SUBJECT: COMANCHE PEAK STEAM ELECTRIC STATION (CPSES)  
DOCKET NOS. 50-446  
TRANSMITTAL OF INSERVICE INSPECTION PROGRAM PLAN  
INTERIM CHANGE REQUEST  
(UNIT 2: 1986 EDITION OF ASME CODE SECTION XI, NO ADDENDA,  
INTERVAL START DATE - AUGUST 3, 1993, FIRST INTERVAL)

Interim Change Request No. ISI-2R0-006

INTERIM CHANGE REQUEST

Plan Title/Rev. Unit 2 ASME Section II Inservice Inspection Program Plan 10 ICR No. 6

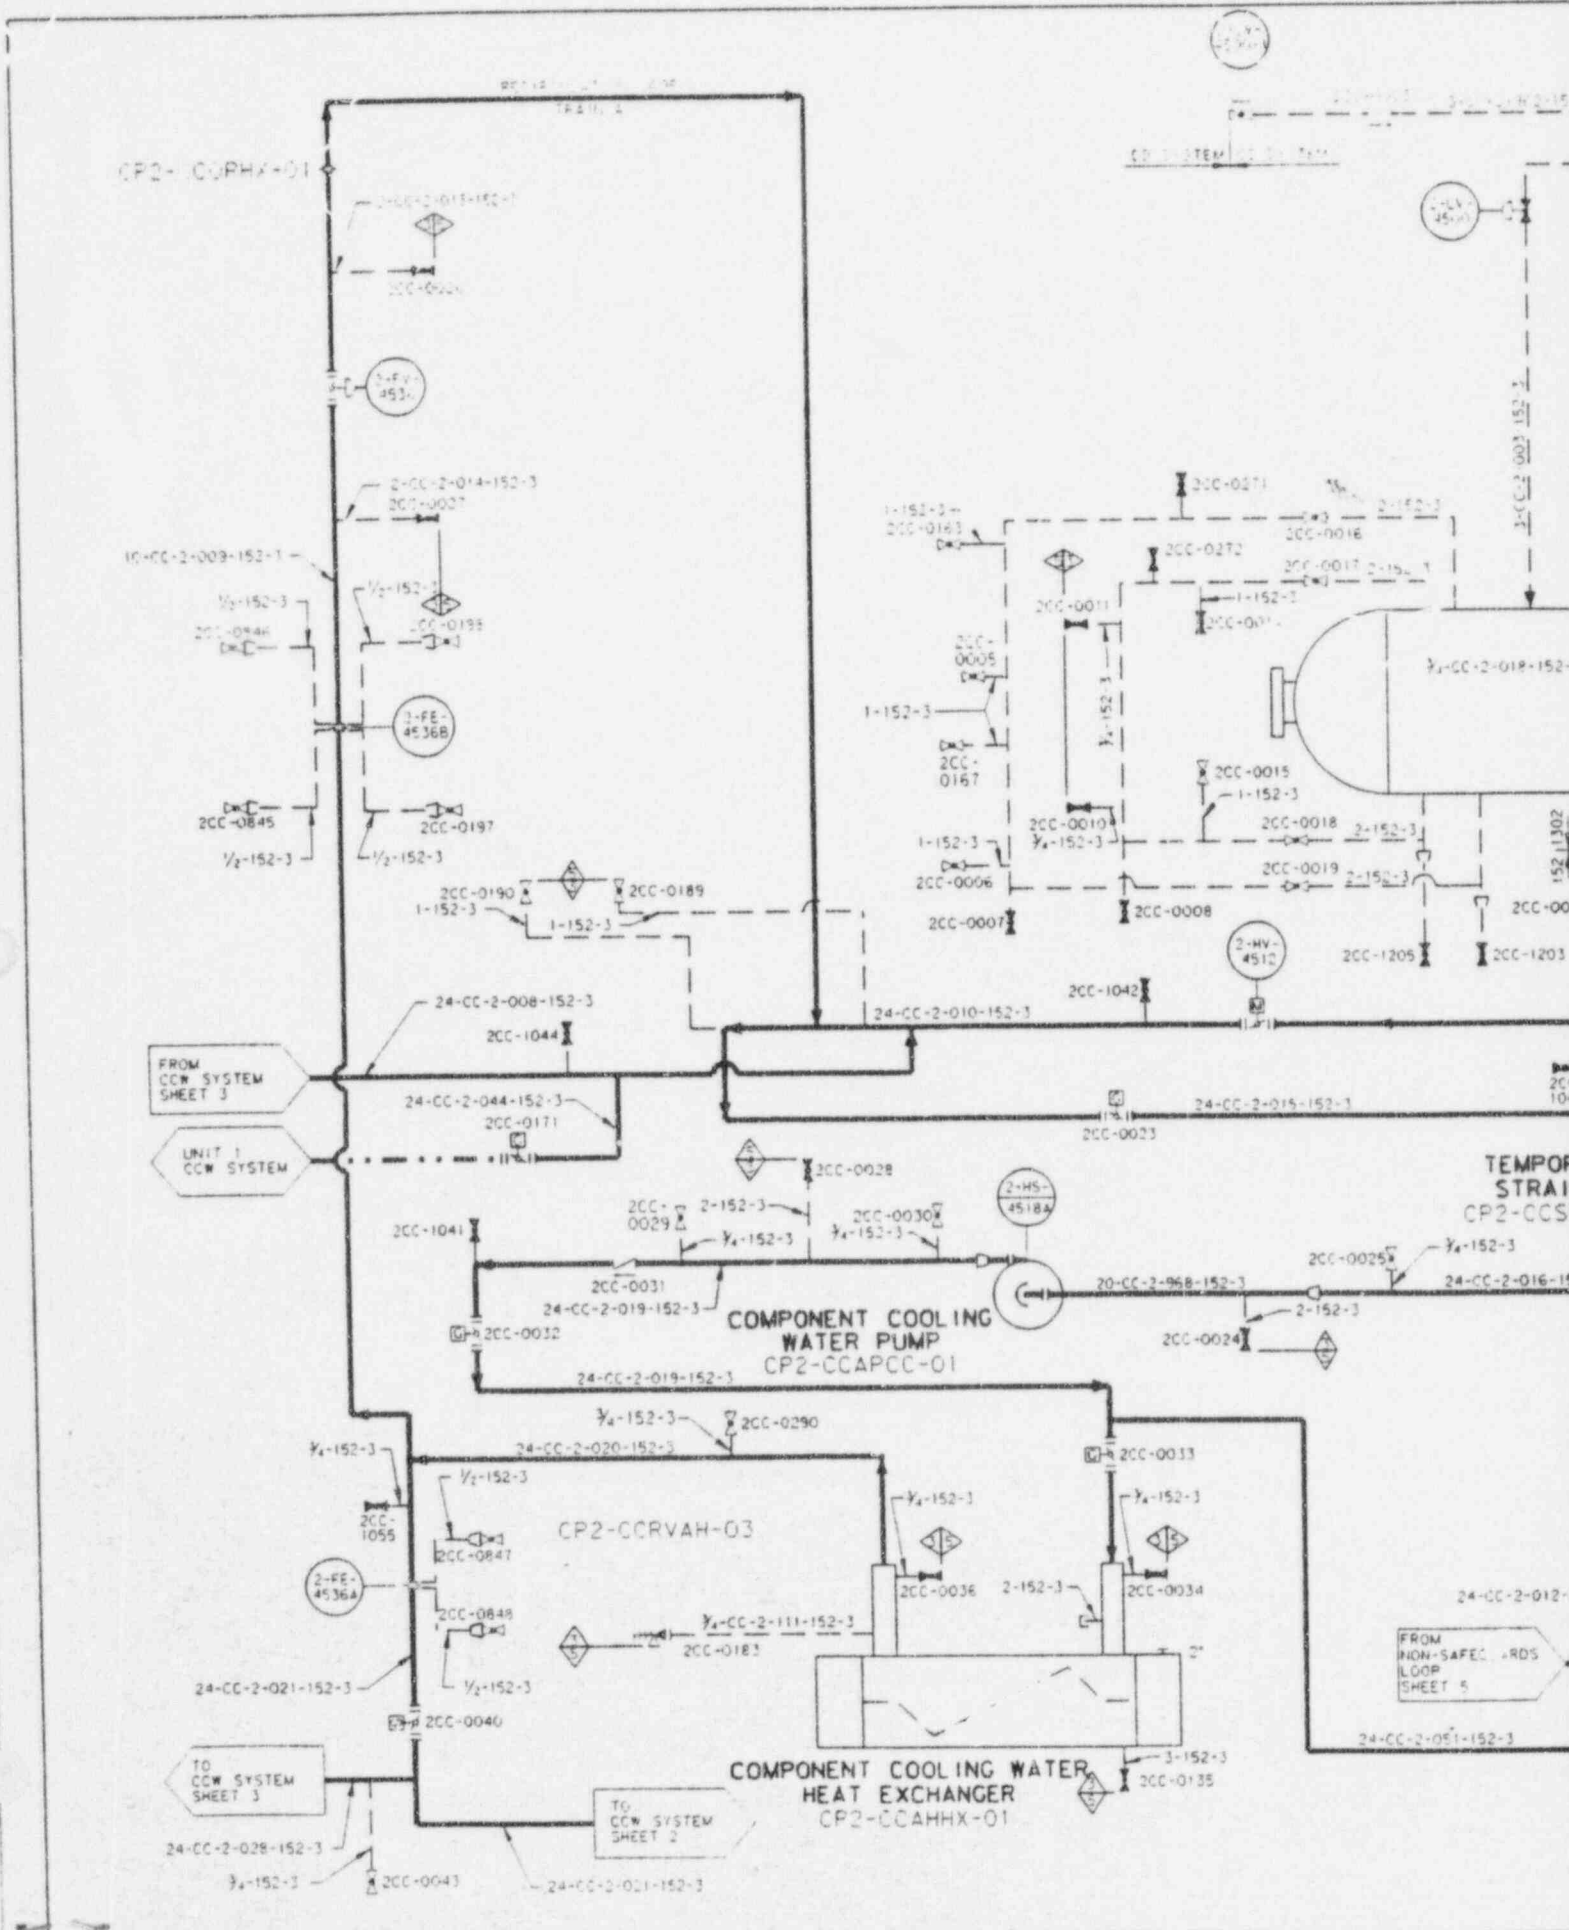
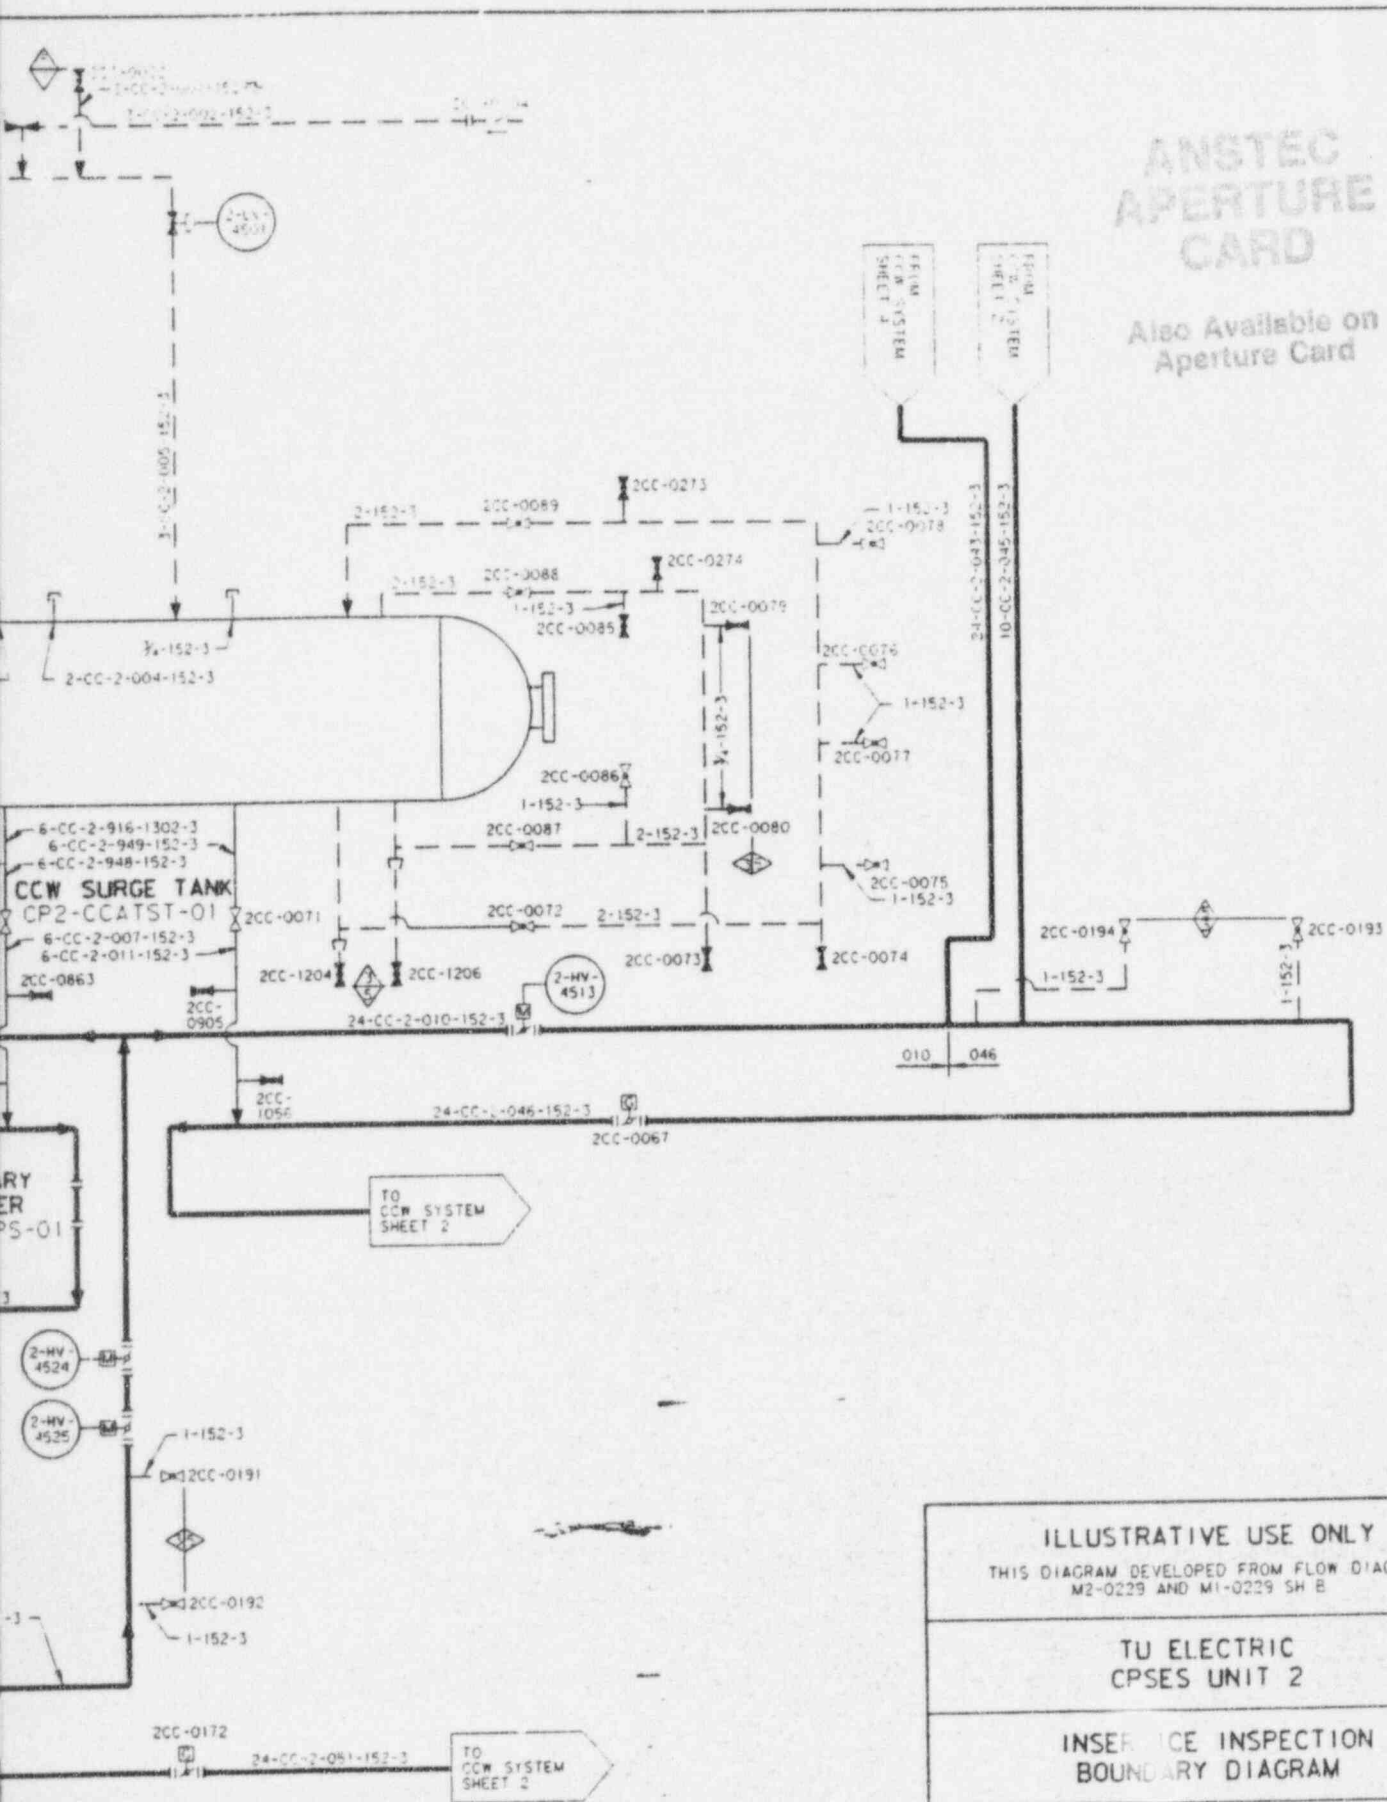
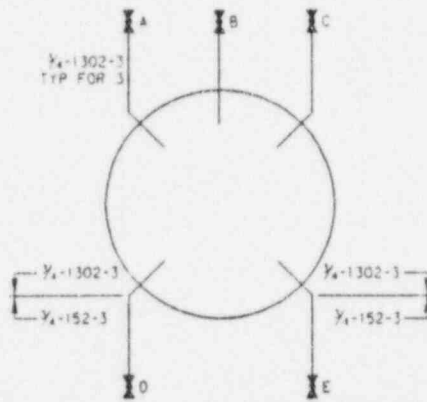
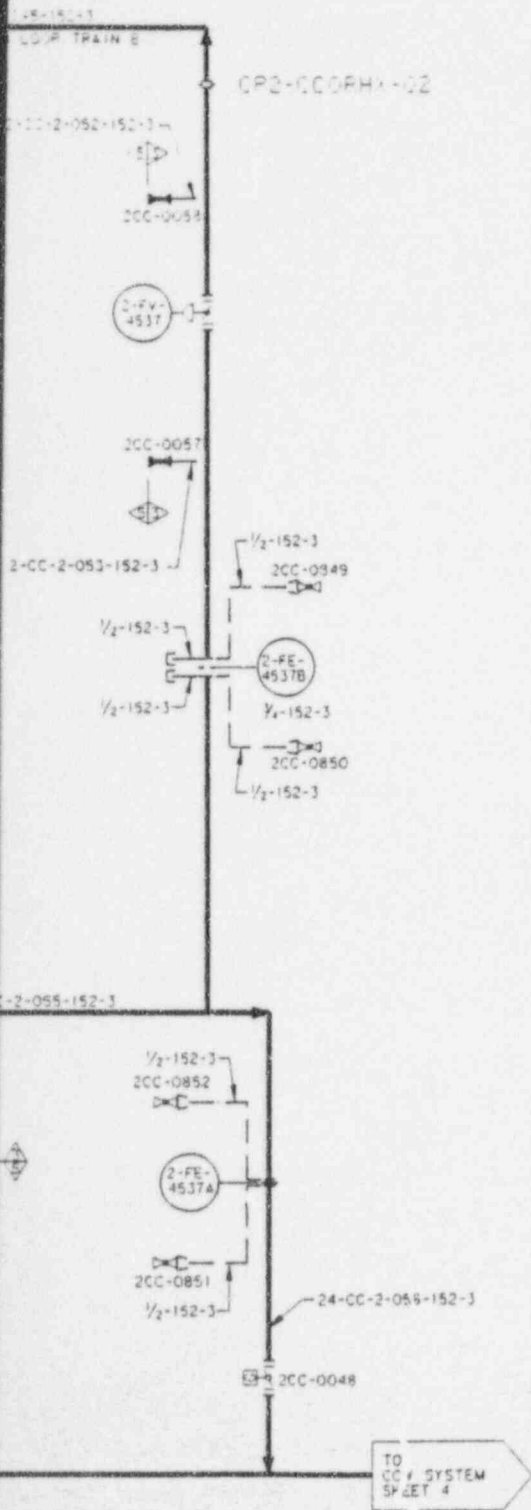
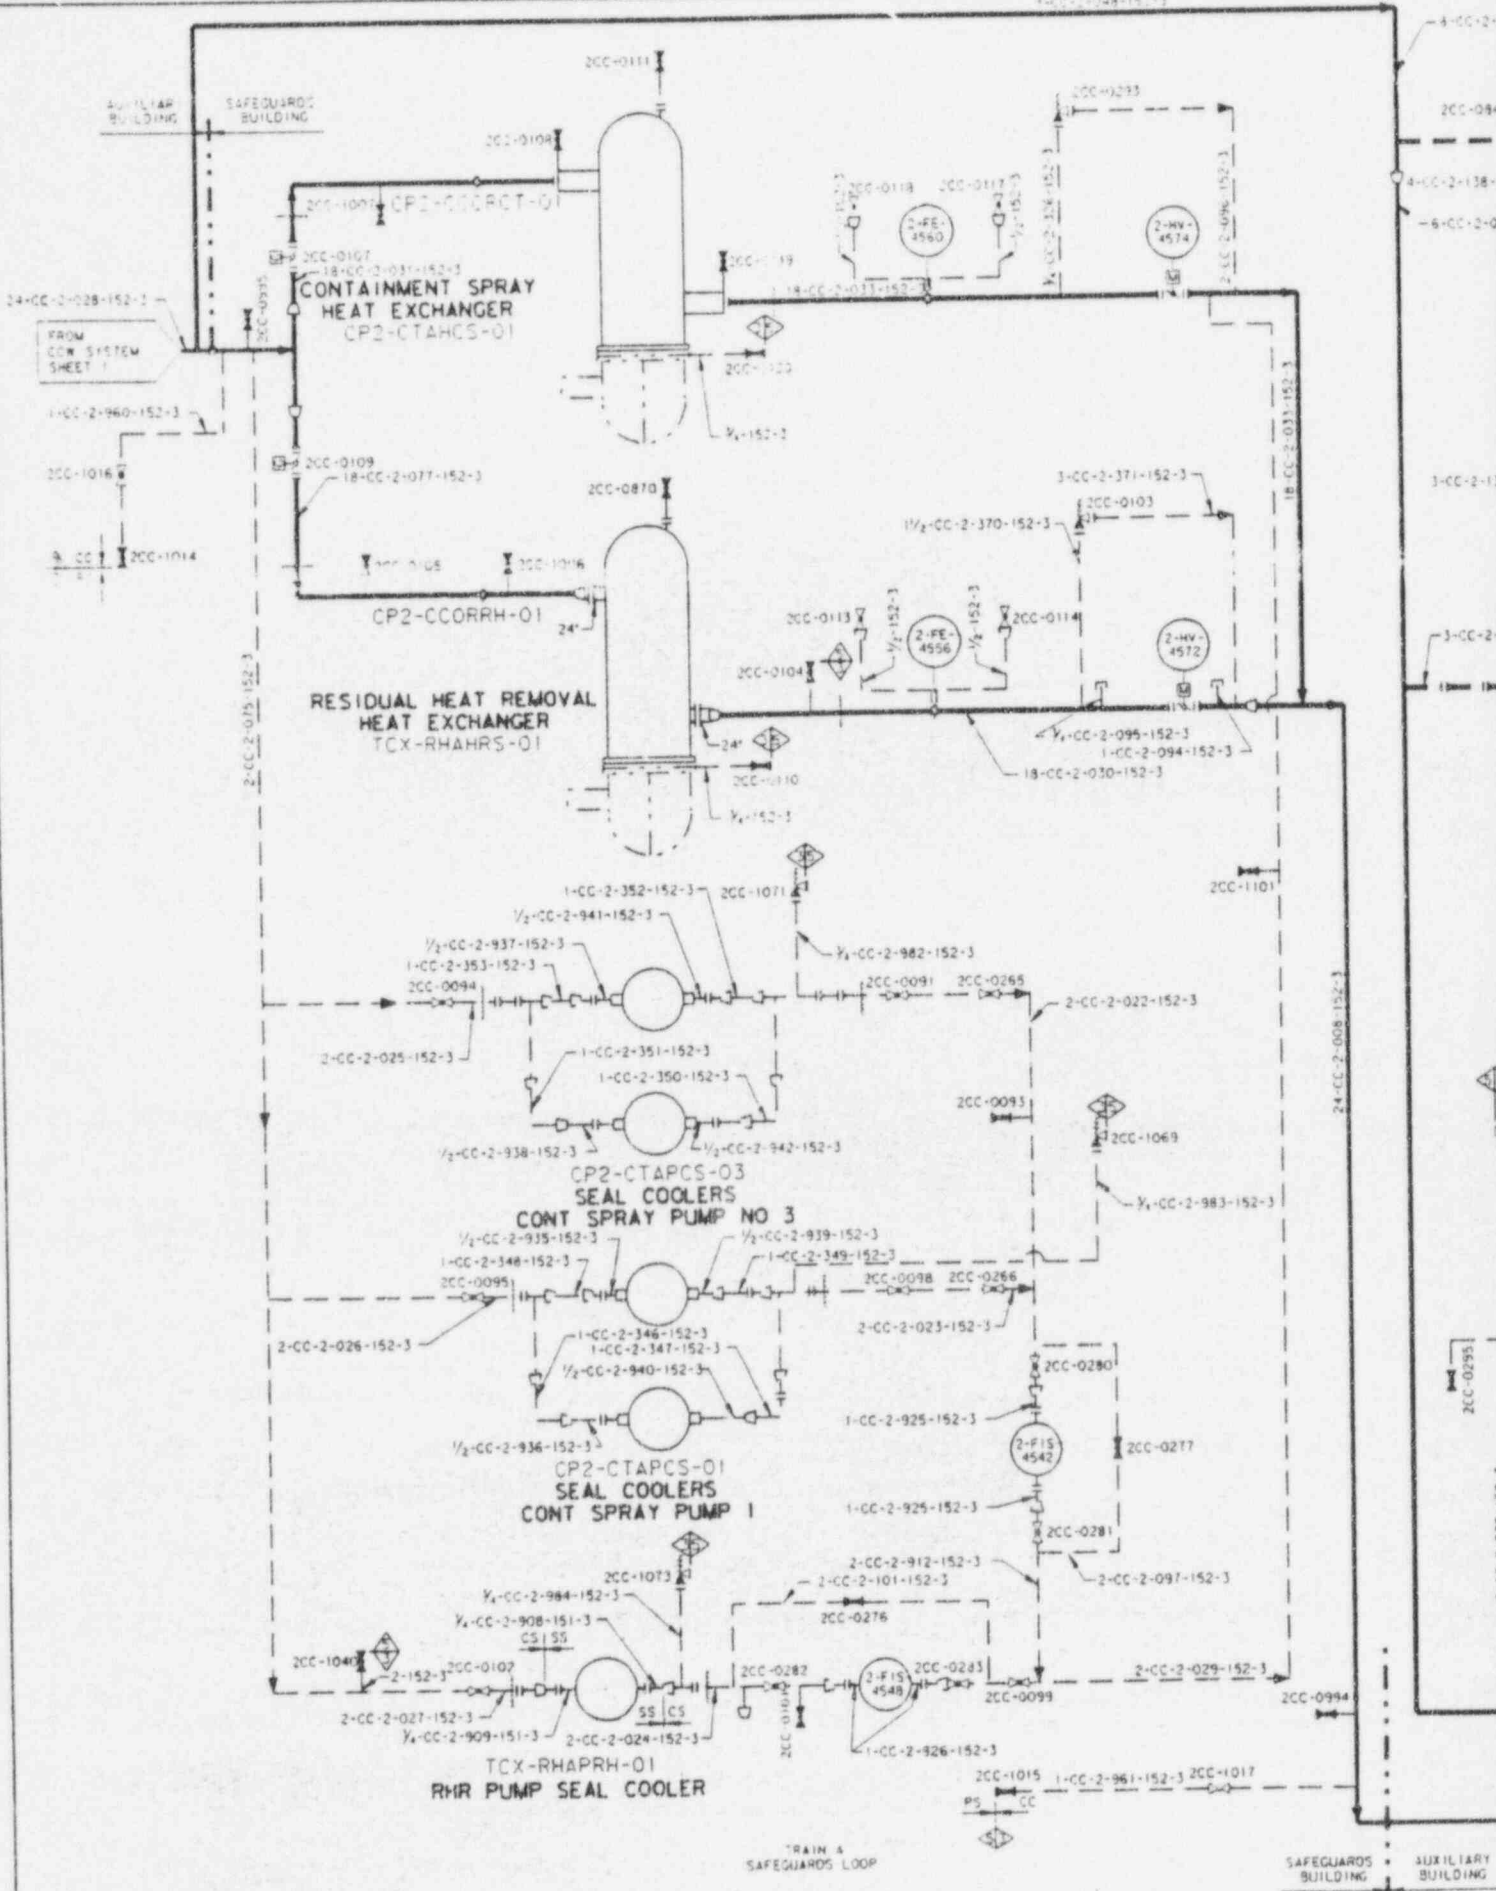
1. CC - Three 24" crossties are provided between Units 1 and 2. Each crosstie is between locked closed butterfly valves. As described in DBD-ME-229, these crossties are not required for any design base accident or safe shutdown. Therefore they do not meet any of the criteria established in Table D-A, D-B or D-C.

The portion of CC which is between containment isolation valves 2-HV-4711 and 2-HV-4710 (both ORC) supplies flow to the shell side of the Reactor Coolant Drain Tank Hx and the Excess Letdown Hx. The Excess Letdown Hx accommodates expansion related flow in excess of the capabilities of normal CVCS letdown during plant heatup. The Reactor Coolant Drain Tank is part of the Waste Processing (WP) system. As described in DBD-ME-264, "Liquid Waste Processing System", the WP system does not perform a safety function. Valves 2-HV-4710/4711 close upon an S-signal. Therefore, the requirements of Category C-H note (7) are met.

Replace Table 9 of Section 5.0 with the attached. Replace the existing drawing with the attached drawings as listed below. A detailed justification of this change is attached.
